Title: Erratum: Non-hysteretic superconducting quantum interference proximity transistor with enhanced responsivity

Erratum: "Non-hysteretic superconducting quantum interference proximity transistor with enhanced responsivity" [Appl. Phys. Lett. 104, 082601 (2014)]

Erratum: "Non-hysteretic superconducting quantum interference proximity transistor with enhanced responsivity" [Appl. Phys. Lett. 104, 082601 (2014)]

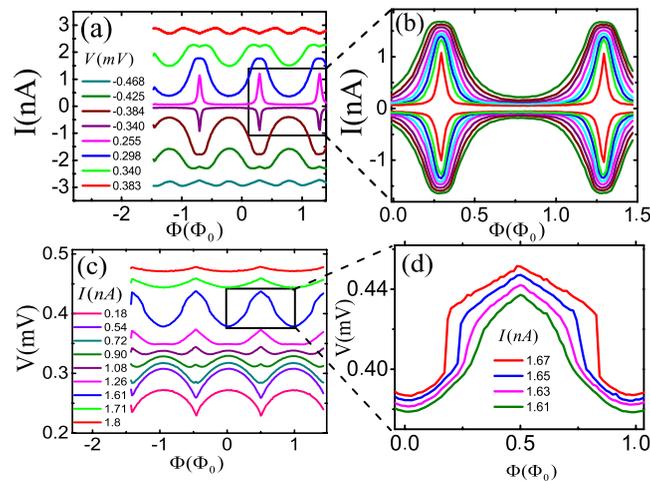
Fig. 3 in the original publication of this paper should be replaced with the following figure and caption. The figure labels in Figs. 3(c) and 3(d) were wrong and we omitted the information that sub-figures (a) and (b) show data from sample A (as defined in Table I) and that sub-figures (c) and (d) show data from sample B.

FIG. 3. (a) Current modulation $I(\Phi)$ of the NIS junction of sample A at different values of bias voltage applied to it at $T_{bath} = 50$ mK. (b) A zoomed view for several values of V in the range $-340 \,\mu$V $< V < 298 \,\mu$V. (c) Measured flux-to-voltage $V(\Phi)$ curves at different magnitudes of current through the junction of sample B and (d) a zoomed image at some values of current in the range 0.18–1.8 nA. The curves are not symmetric around $\Phi = 0$ due to a constant offset flux bias. The suppression of hysteresis is visible in both $I(\Phi)$ and $V(\Phi)$ modulations. This happens as the Josephson inductance L_J exceeds the self-inductance of the superconducting ring.
